# WORLD WAR II MEMORIAL: FDR D-DAY PRAYER DESIGN DEVELOPMENT

PRESENTATION TO THE NATIONAL  
CAPITAL PLANNING COMMISSION

## Letter Re: FDR Prayer Concept

CFA 21/JAN/21-1

## History and Overview | 2016 Placement within the Circle of Remembrance - Center Prayer Plaque Studies

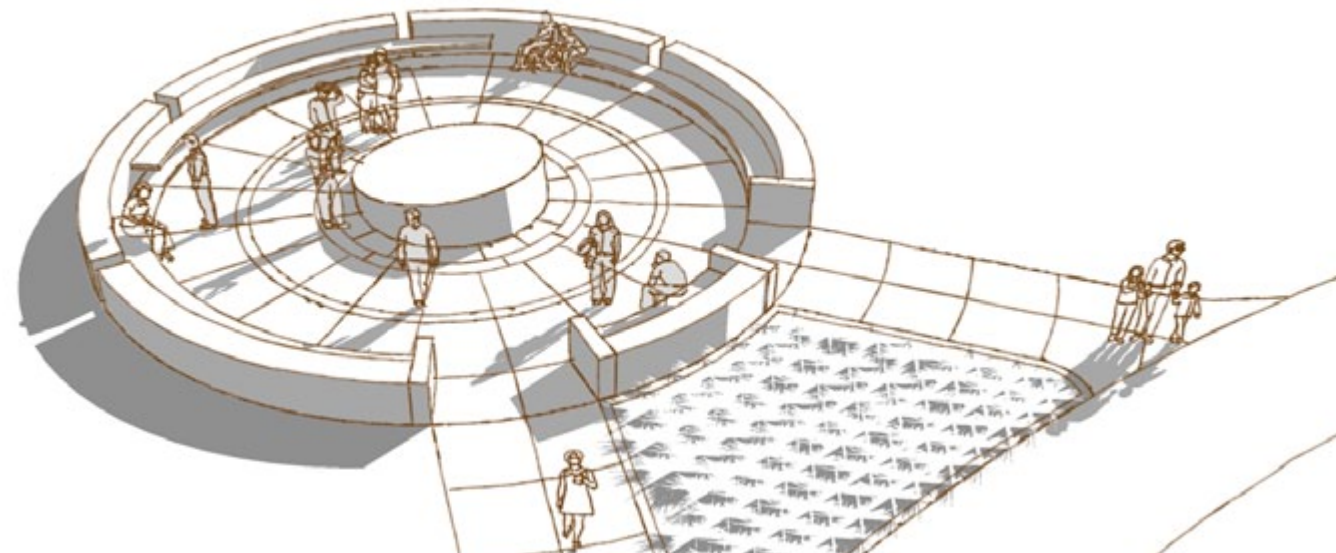
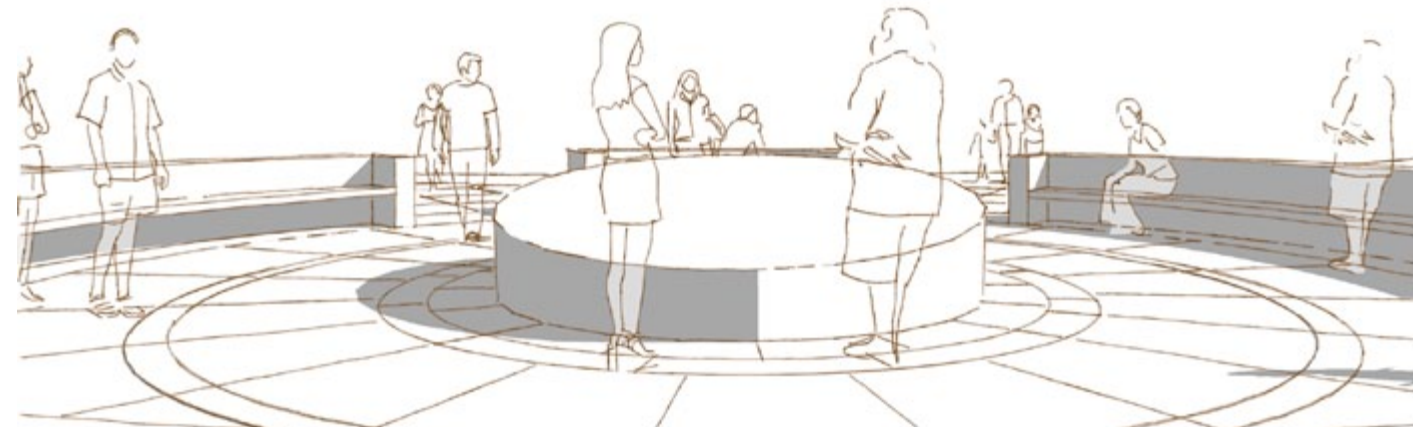
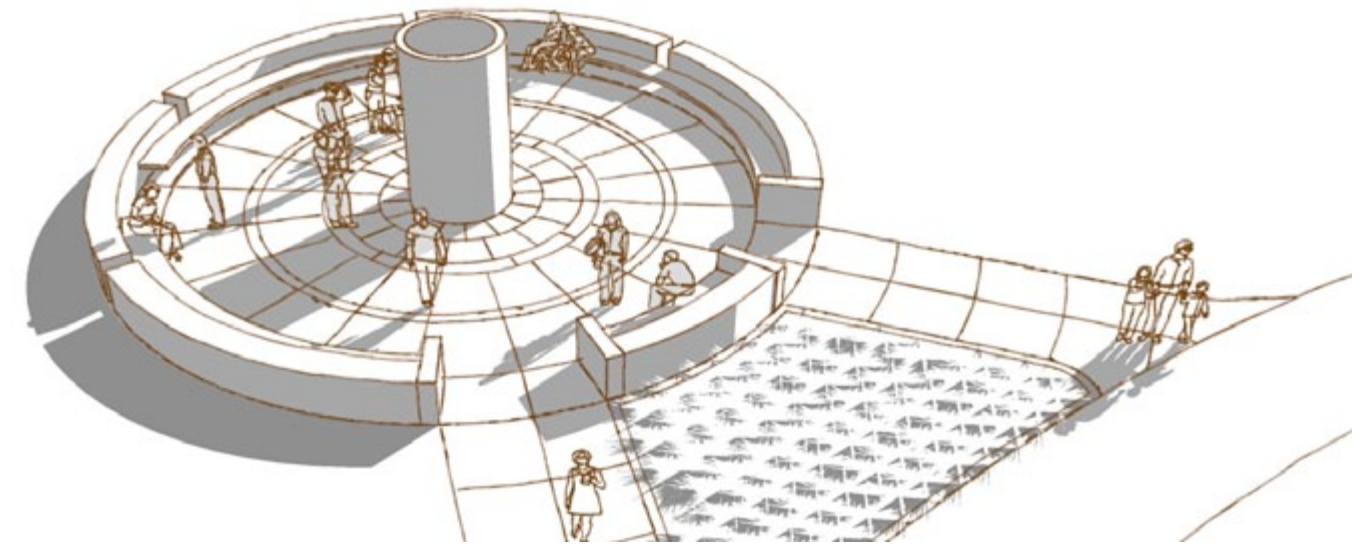
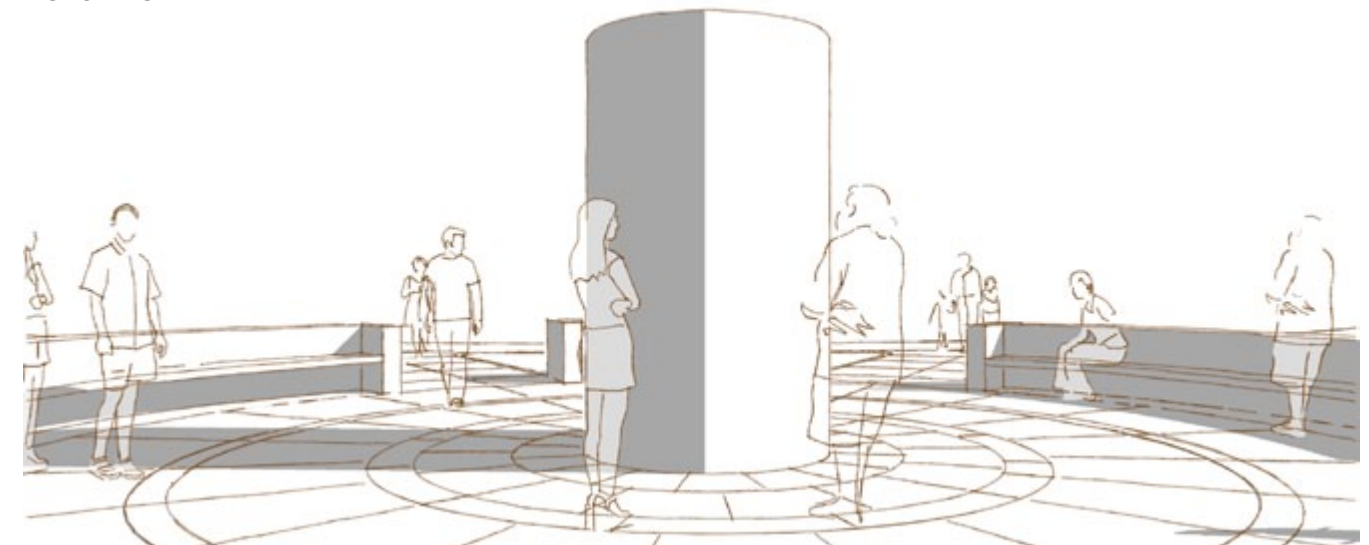
In previous review, Commission noted: *“The second alternative should explore a different location for the prayer text, away from the entrance, possibly in the geometric center, which is otherwise vacant.”*

- Center was studied during the siting process and was removed from consideration due to inability to meet design criteria
- Poor visual connection with WWII Memorial
- Incompatible with circulation and visitation patterns (annual D-Day gathering )
- Commission noted Plaque would be too large in the center of the Circle and advised studying other locations

While a central vertical element did not fit the design program, the revised submission includes a proposal for activating the center with a medallion

## Revised Circle and Prayer Plaque Design | View to WWII Memorial

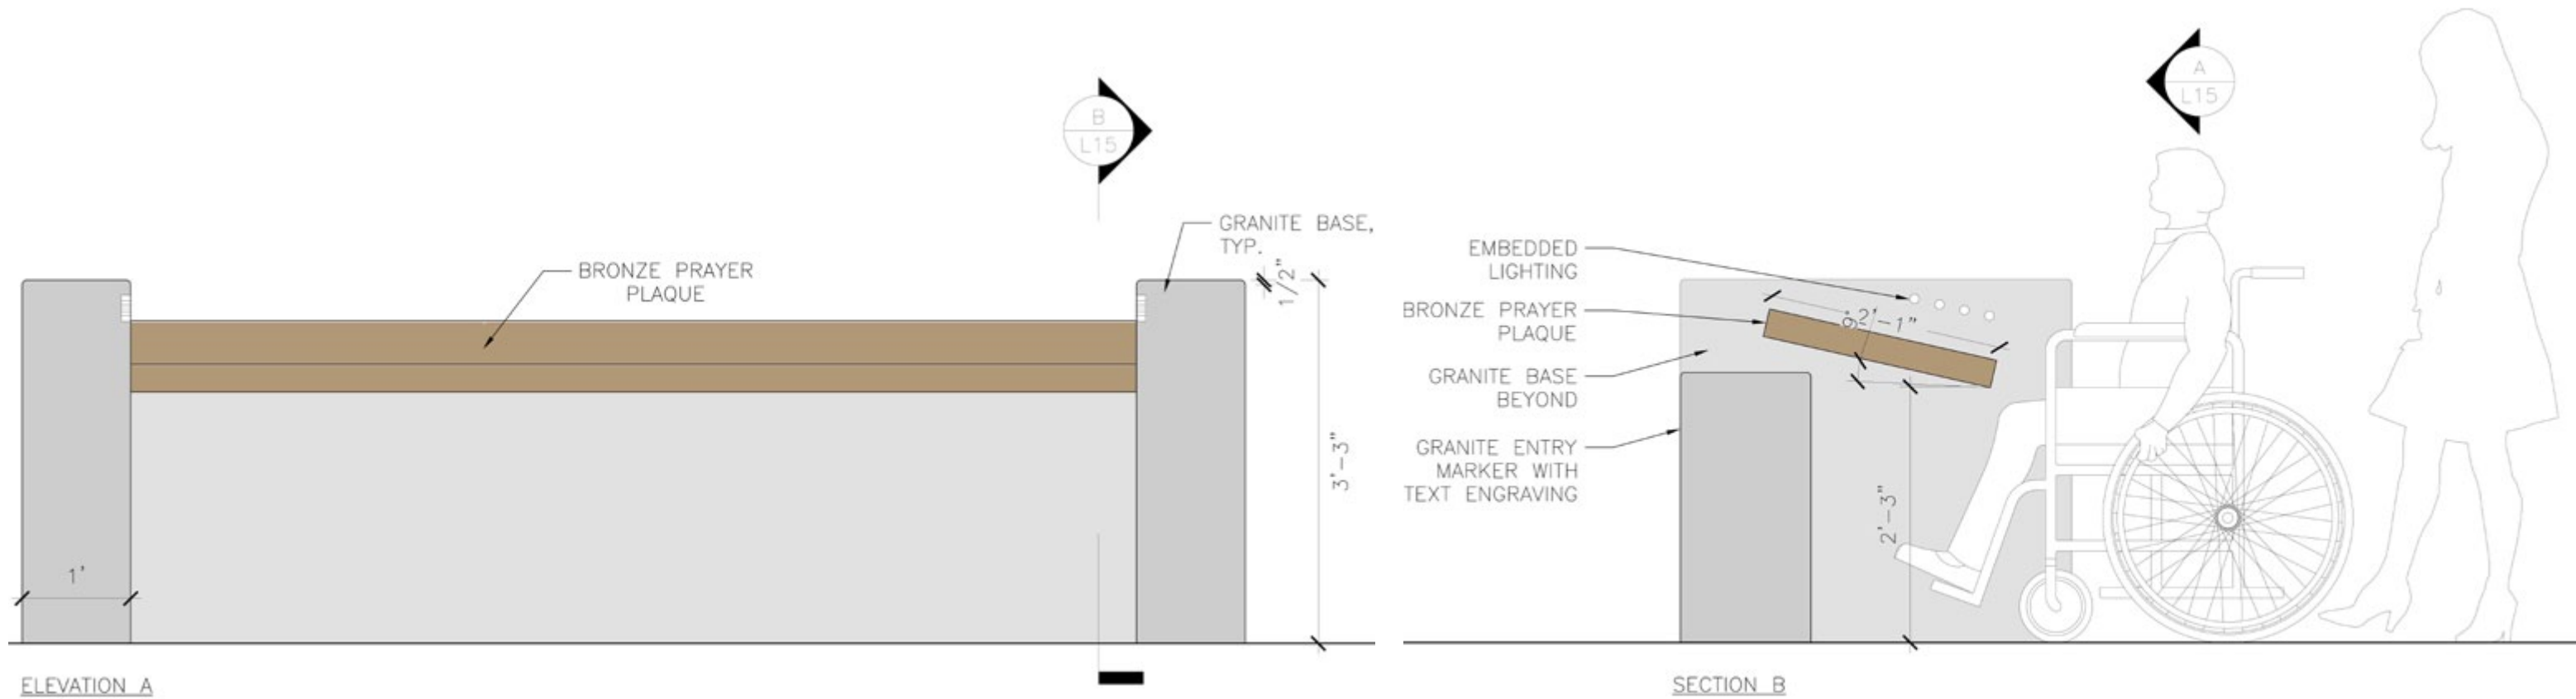
- **“a clear relationship to the larger composition of the World War II Memorial”**
- **“the plaque should be larger in scale to reinforce its significance”**
- **“enframing and support of the plaque be made more solid and substantial”**
- **“text in a pattern that reflects the gently curving geometry of the circle, and using a larger size of letters”**
- **“further study of the typeface”**
- **“explore a different location for the prayer... possibly in the geometric center...which is otherwise vacant”**
- **“the perimeter...could be less architecturally articulated”**

- Clear view of WWII Memorial while reading Prayer
- Lower site walls and plaque enframement create stronger visual connection to the WWII Memorial
- Granite base provides strong foundation for Prayer Plaque while allowing wheelchair access
- Angle of Prayer Plaque reduced to minimize Plaque enframement height
- Medal of Freedom incorporated into center of the Circle

## Precedent | Treatment of the Center

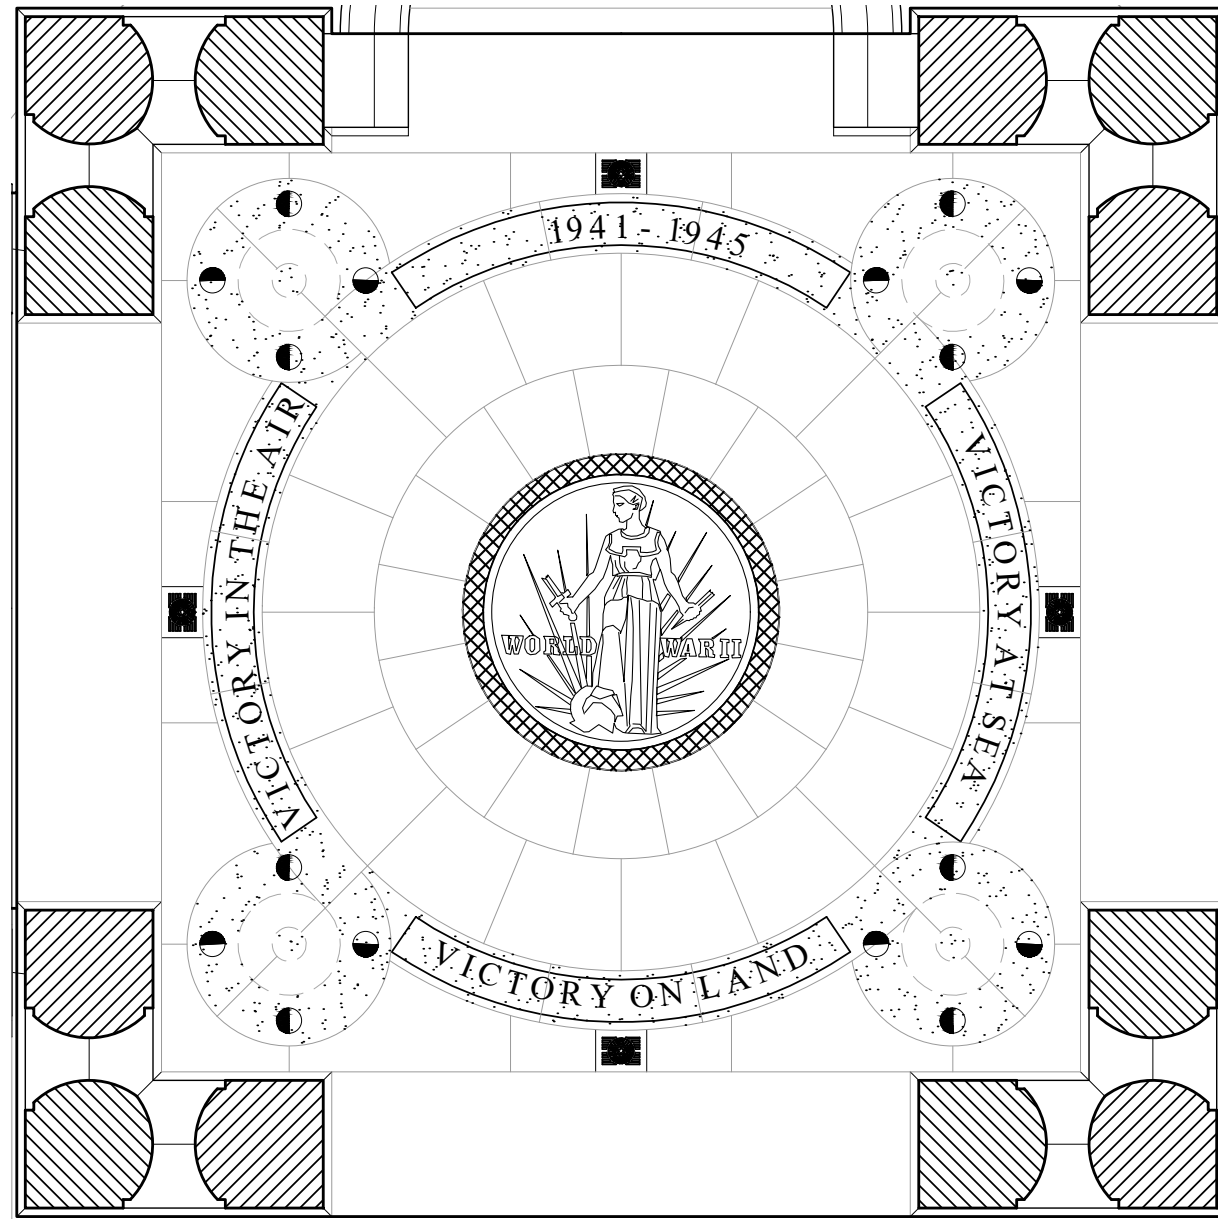
- In response to the Commission's comment regarding the Circle's 'vacant' center, a paving emblem is proposed
- WWII Atlantic and Pacific Arches provide inspiration for development of Circle's center paving design
- Bronze WWII Medal of Freedom, awarded to any veteran or civilian who performed a notable service
- Dark grey ring of 'Moss Green' granite with bronze inlay
